Beaver Valley Power Station
Unit Nos. 1 and 2

License Amendment Requests
302 and 173

Extended Power Uprate

Subject: Beaver Valley Power Station, Unit No. 1 and No. 2
BV-1 Docket No. 50-334, License No. DPR-66
BV-2 Docket No. 50-412, License No. NPF-73
License Amendment Request Nos. 302 and 173

Figure 4.2-6
Reactor Coolant System Cooldown (up to 100°F/Hr.)
Limitations Applicable for the First ~~14~~22 EFPY (TS 3.4.9.1)

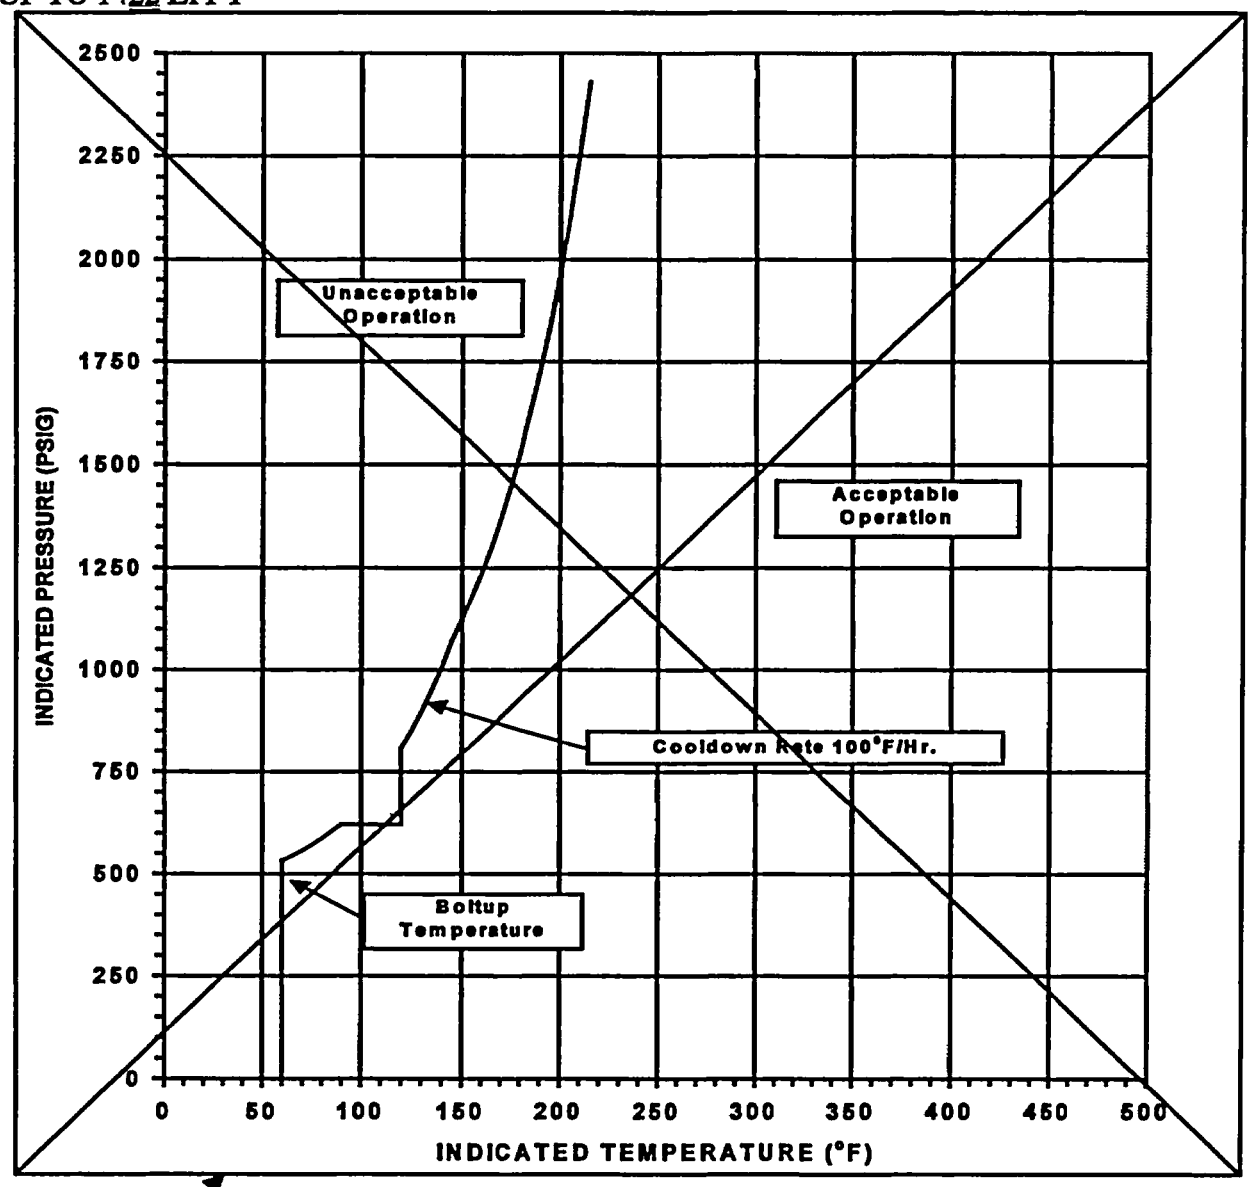
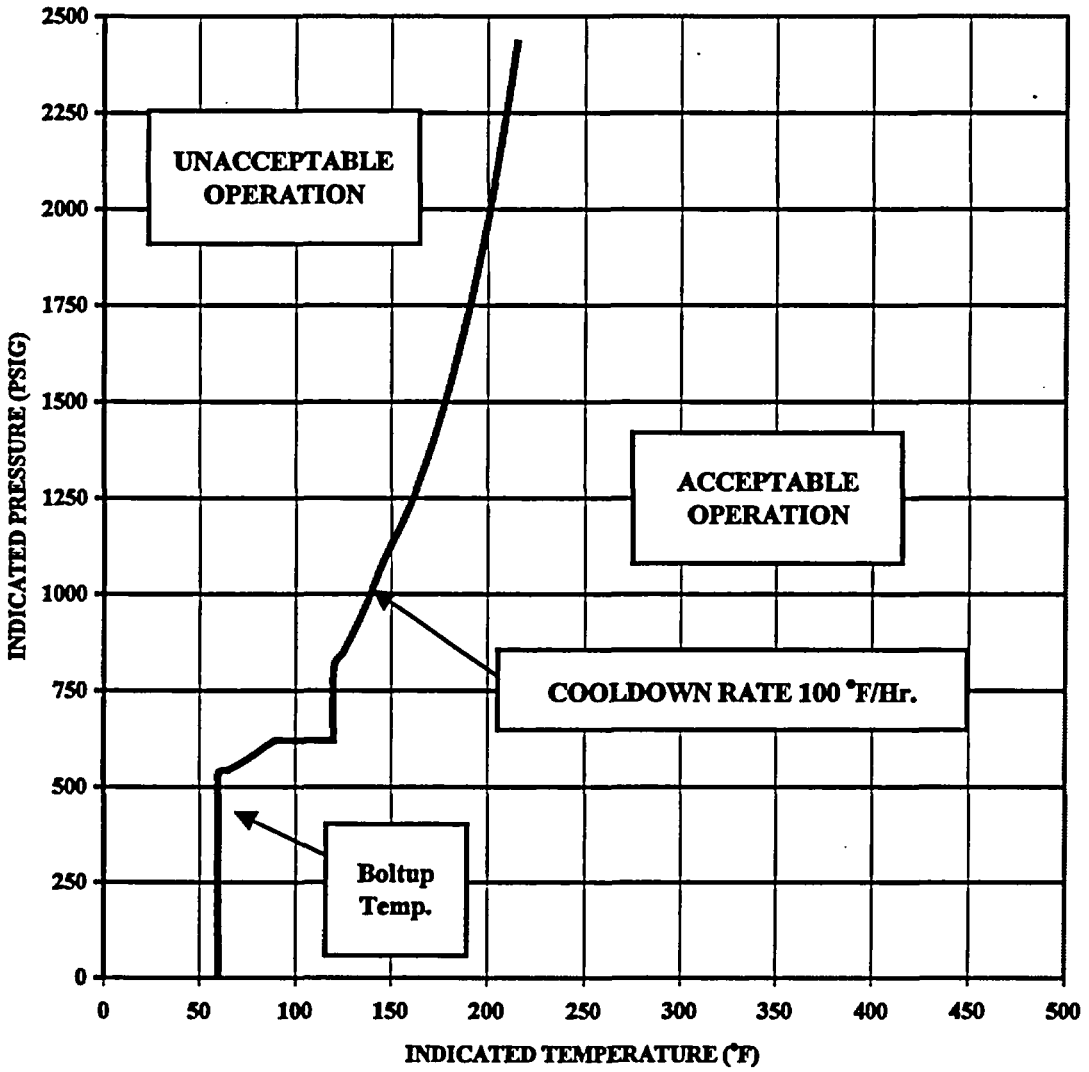
CONTROLLING MATERIAL:	INTERMEDIATE SHELL PLATE B9004-1
INITIAL RT_{NDT}:	60°F
RT_{NDT} AFTER ~~14~~22 EFPY:	1/4T, 140°F
	3/4T, ~~128~~129°F

Replace with Insert C2-9.

Insert C2-9.
